MEMORANDUM ADDENDUM #1

TO: All Bidders
FROM: David Chen
DATE: June 6, 2025
RE: Pearl River Public Library – Complete Renovation Project

Pearl River Public Library – Complete Renovation Project

ADDENDUM NO. 1

1 CONSTRUCTION DIMENSION PLAN
1/4" = 1'=0"

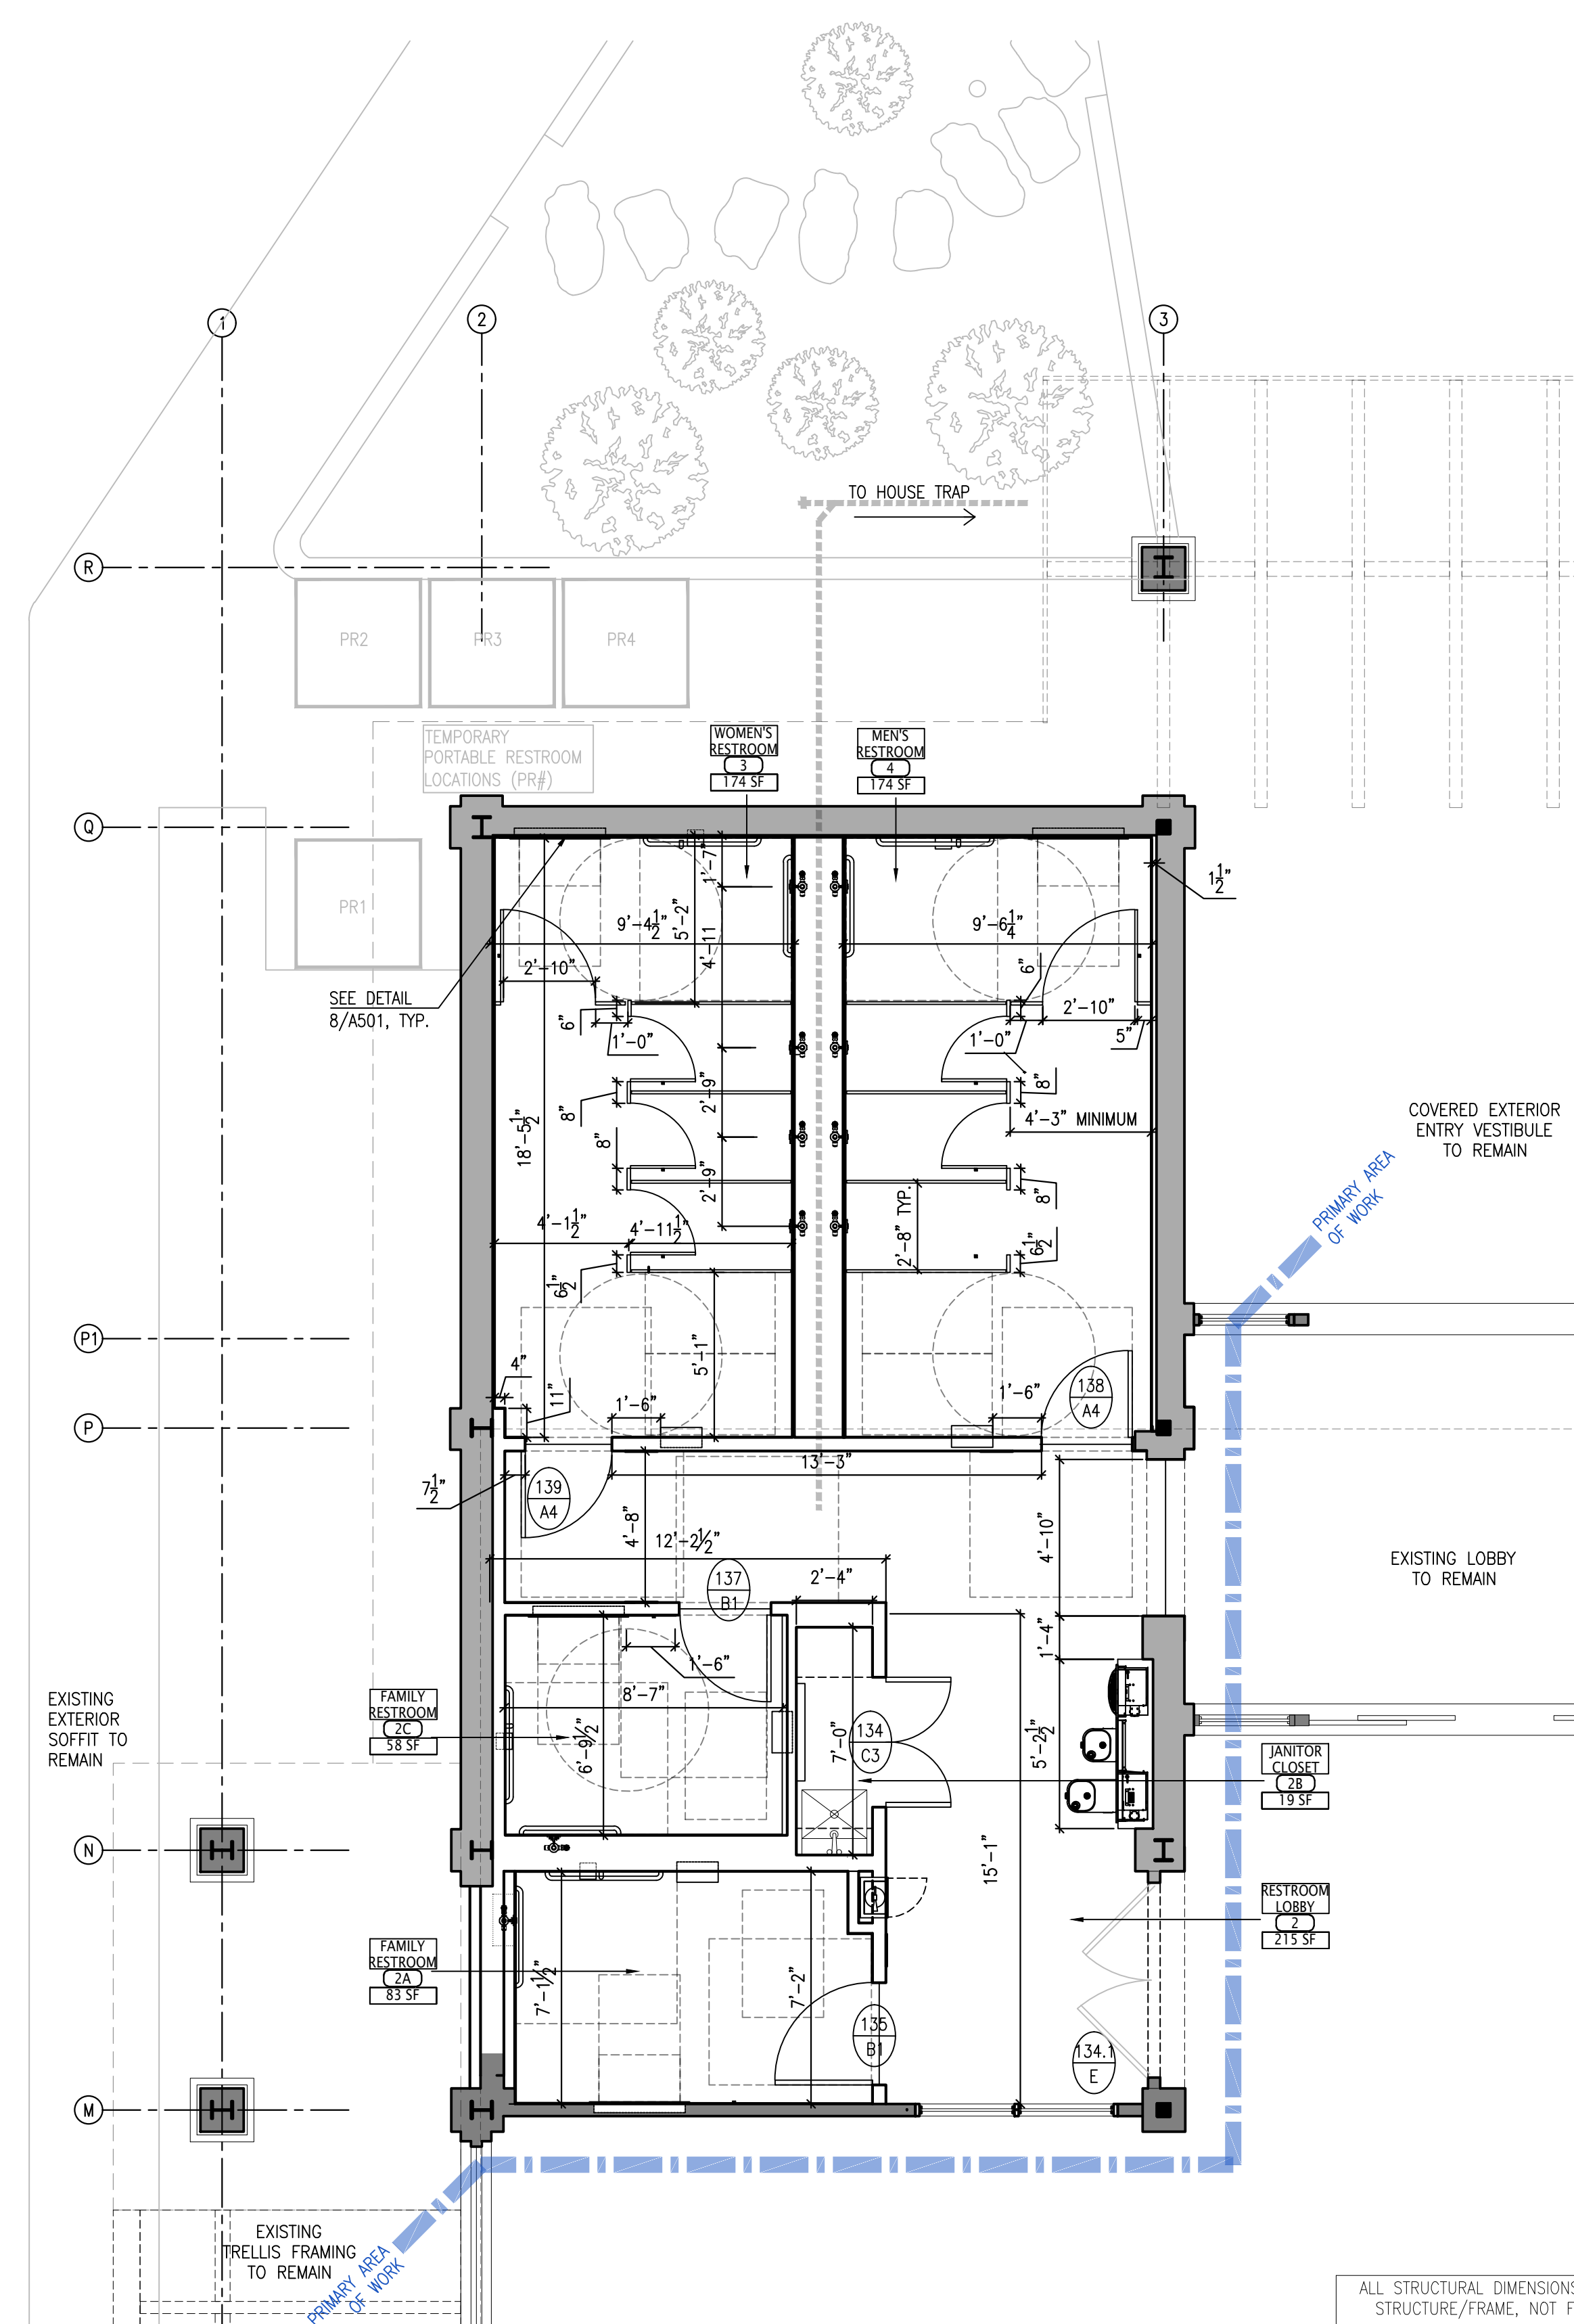
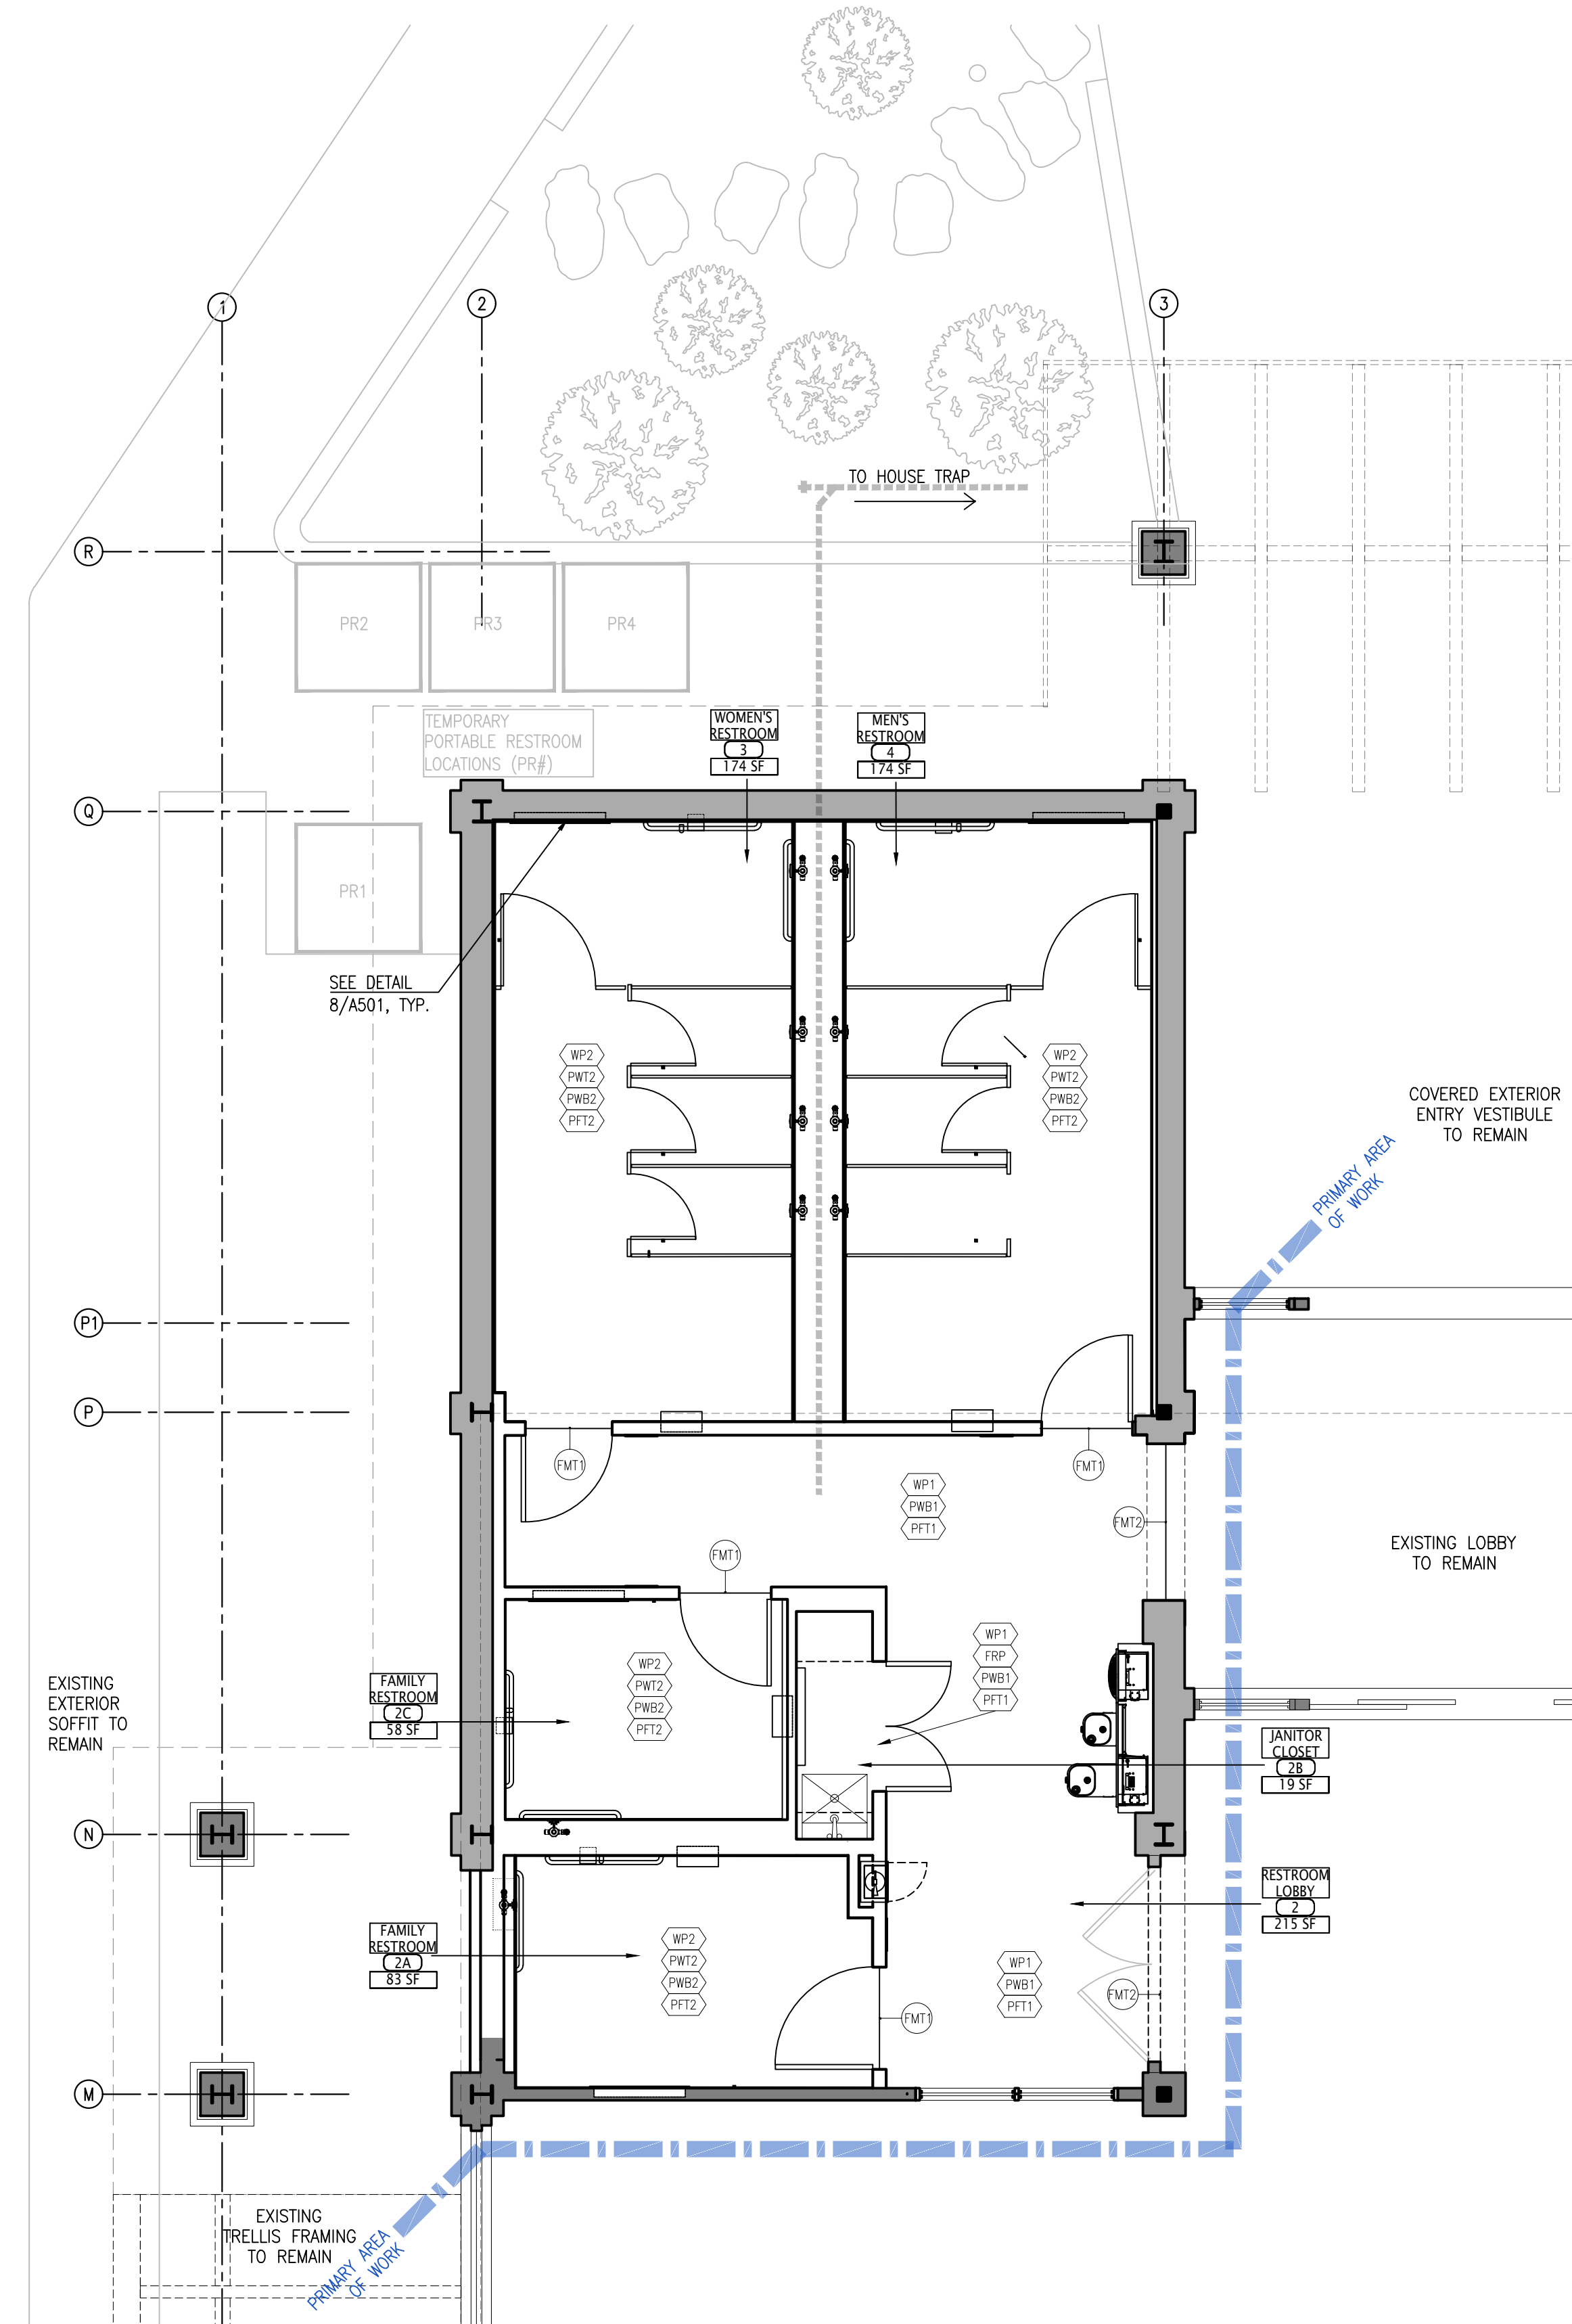
14. **Question:** On the Restroom Renovation portion of the project there are no architectural demolition drawings. Please advise.
- a. **Response:** See Superseded Restroom Renovation Set “2.1 - 2578-01_23_0602 - PRPL RESTROOM BID SET AR (14p) (ADDENDUM 1)” on sheet A103 drawing 2 for Demolition Plan.
